ORDER UNDER SECTION 96 (2) OF ACT III OF 1901.

With reference to his application, dated 16th April 1918,
Mr. Gabindram Shenaldas is informed
amended
that the plan submitted by him for building a house
on plot No. 21, Survey Sheet C5,
situate in Marmat Road Street, marked
Quarter, is approved, and permission to build in accordance therewith is
granted. The building to be erected subject to the By-laws and Rules of the
Municipality.

AMENDED PLAN OF BUILDING
ON PLOT NO. 21, SHEET. C. 5.
MARKET QUARTER

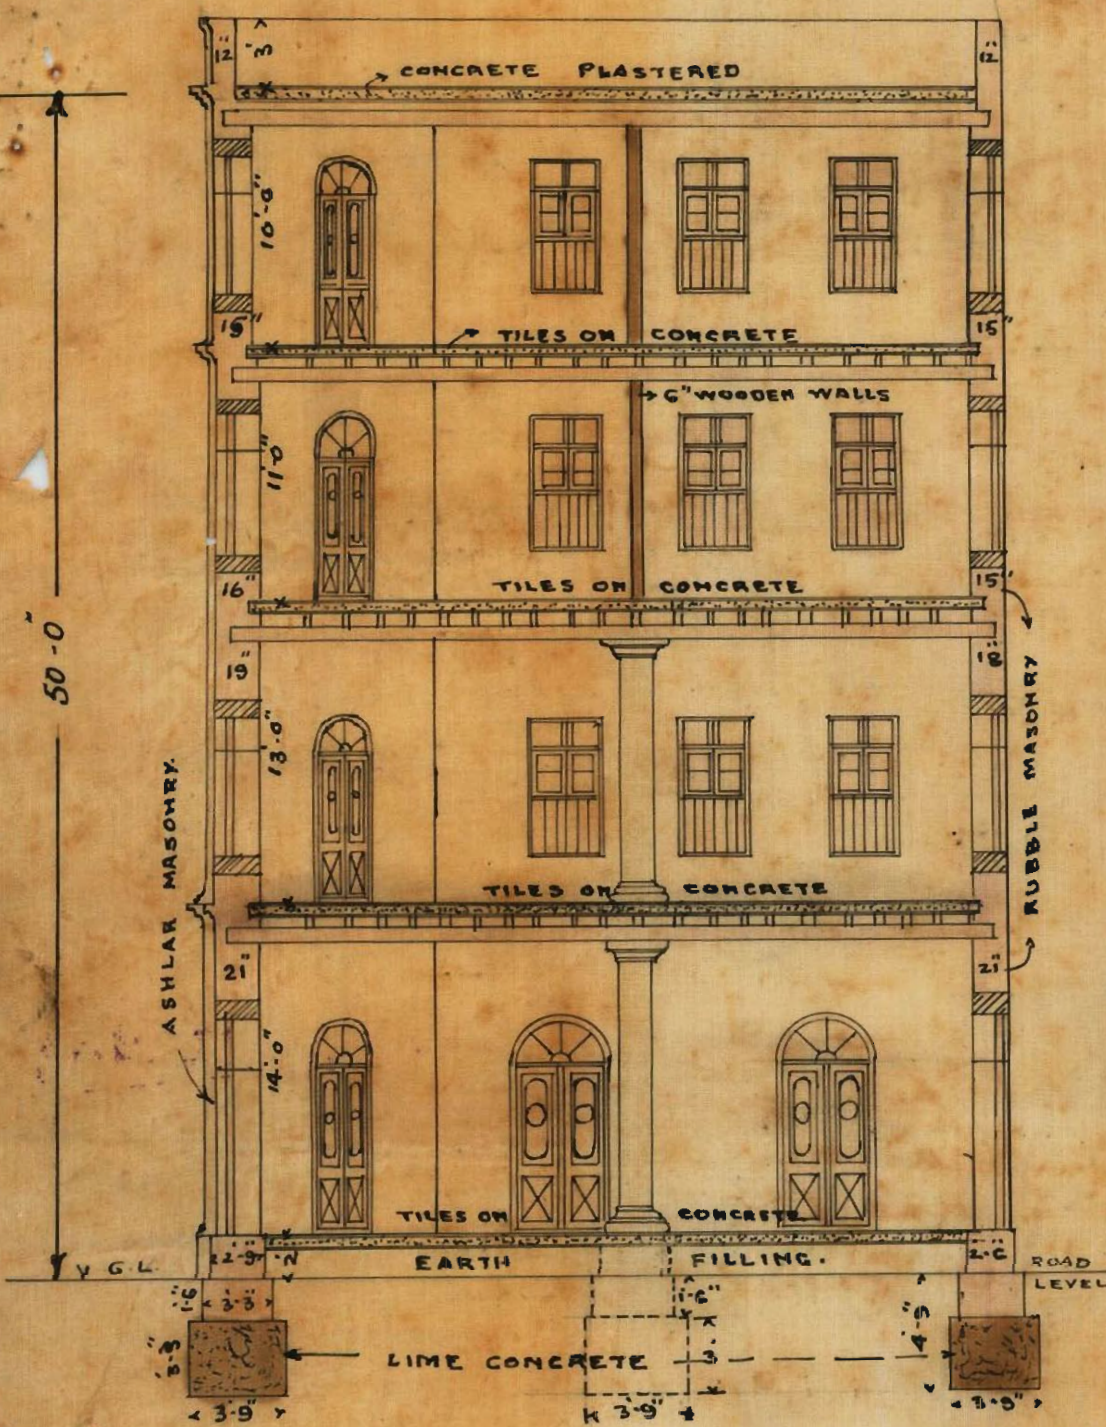
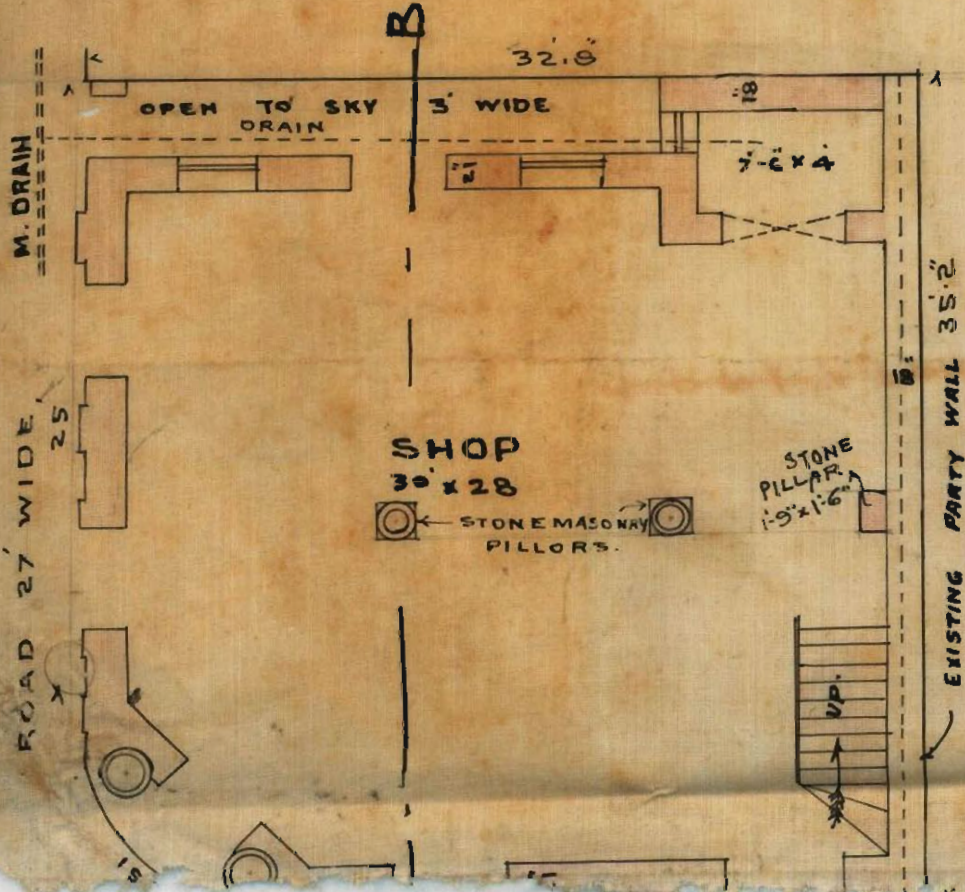
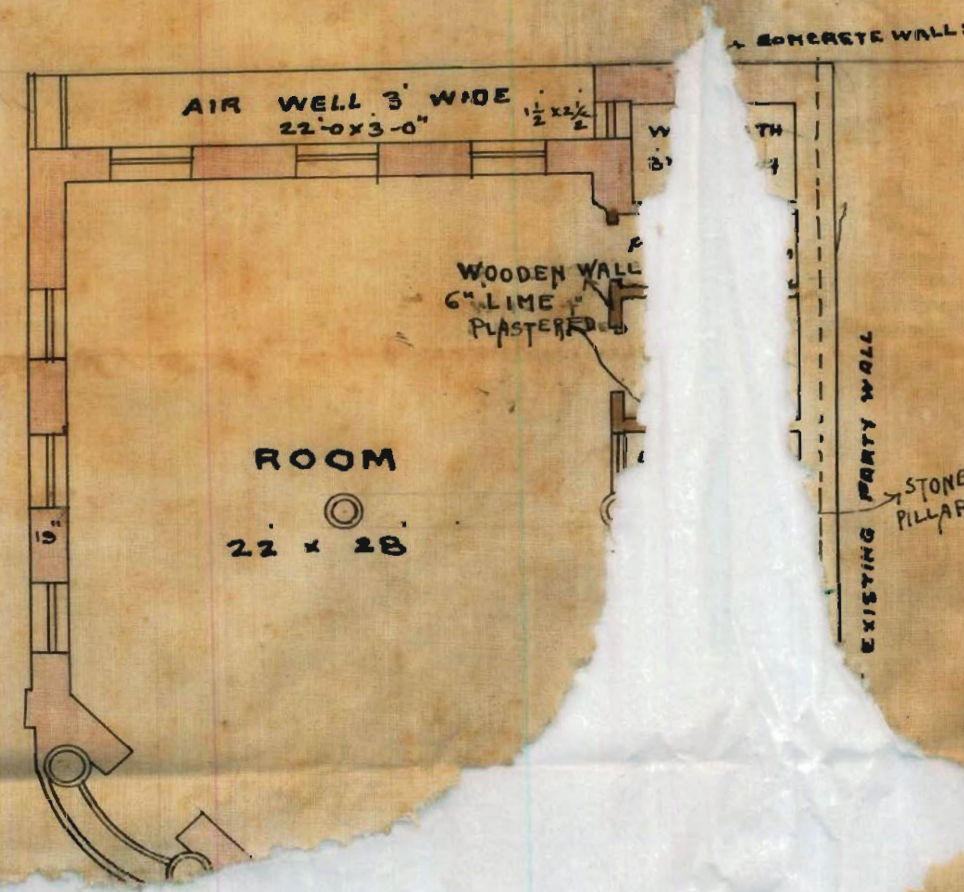
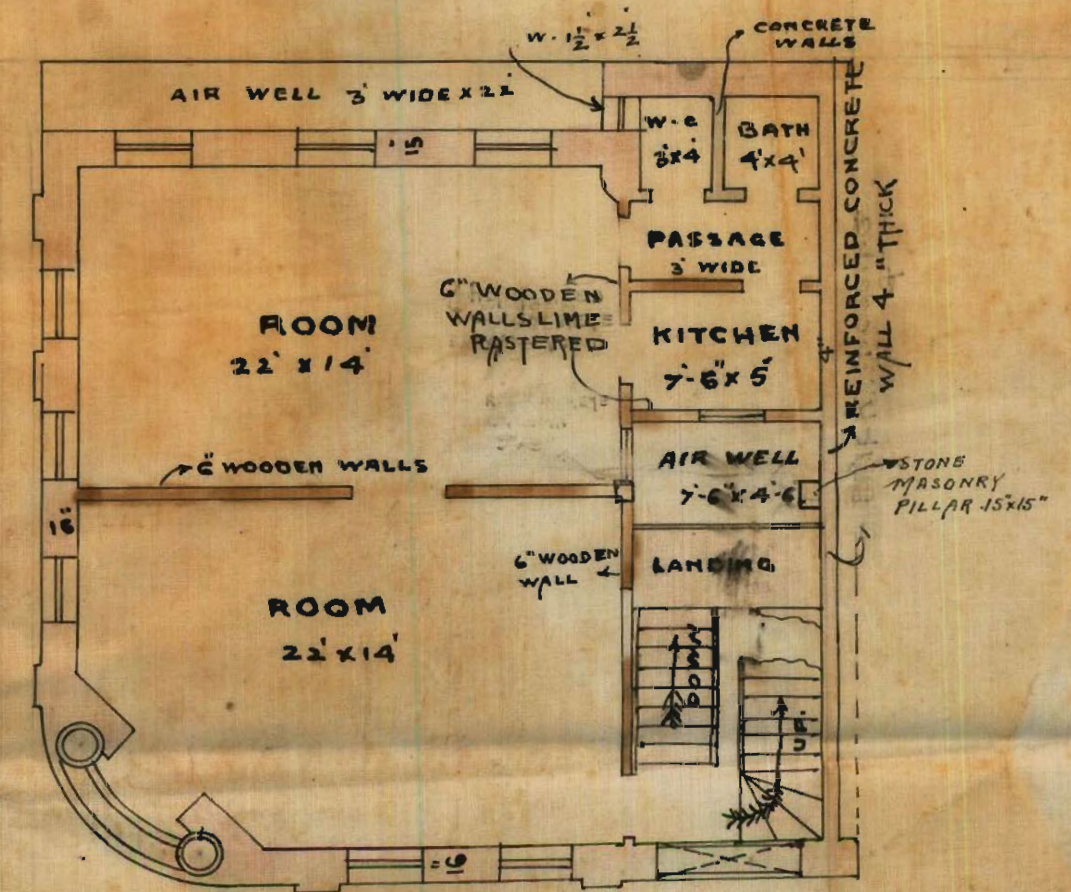
With reference to his application dated 13th March 1918 submitting amended plan of the building under construction ^{Market} on Plot No: 21 - C 5 ~~XXXXXXXXXX~~ Quarter Mr Gobindram Shiwaldas is informed that the external wall to the east 50' high of bricknogging is not good enough and can not be permitted. The owner agreed on the ground to use 6" reinforced concrete to ^{plan} work and unless that is done and shown on the plan the ~~same~~ can not be approved and ⁷returned herewith for amendment.

In continuation of this office No:E/2220 dated 28th
February 1918 Mr: Gobindram Shivandas is informed that the
March
existing eastern wall shown on the ammended plan of building on
Plot No: 21 - C 5 Market Quarter is not good enough to carry
the building. Provision must be made for a pucca wall properly
tied in. The work must be stopped ^{and} in the building, ^{made to} conformed to
the approved plan, failing which steps will be taken against
him under the Act.

With reference to his application dated 18th Feb. 1918 with amended plan for plot No. 21, C-5 Market Quarter Mr: Gobindram Shivandas is informed that it is observed that he is already erecting the building contrary to the sanctioned plan as explained to him on the ground by Undersigned. The foundation of the Eastern existing wall must be opened for Undersigned inspection on Monday 4th March at 8-30 A.M. The work already carried out contrary to the approved plan must be stopped atonce till the amended plan is sanctioned *failing which it will be removed at his risk & cost.*

The existing Eastern wall is not good enough to carry the building. Provision must be made for a pukka wall properly tied in at the place between the kitchen & the kitchen. On this

He reports that the owner of plot no
21 CS Ebrahim Sherali having
acquired a portion of land for the adjoining
plot no. 22 CS is seeking on that portion
also - This is not shown on the
ancient plan. Further he is not
providing a wall to the east which
is shown on the approved plan. He may
be required to stop the work & submit
an amended plan. Report and

I beg to resubmit the plans for building on plot no 21 - Sub 6.5 Market Quarter. Reinforced concrete will be used for the east wall in place of Bricknogging as shown the drawing now & as directed in your letter of no E 3015 dated 3rd April 18. The concrete will however be 4 1/2 to 4" thick. I beg to request that you will kindly approve of the plan as so modified.
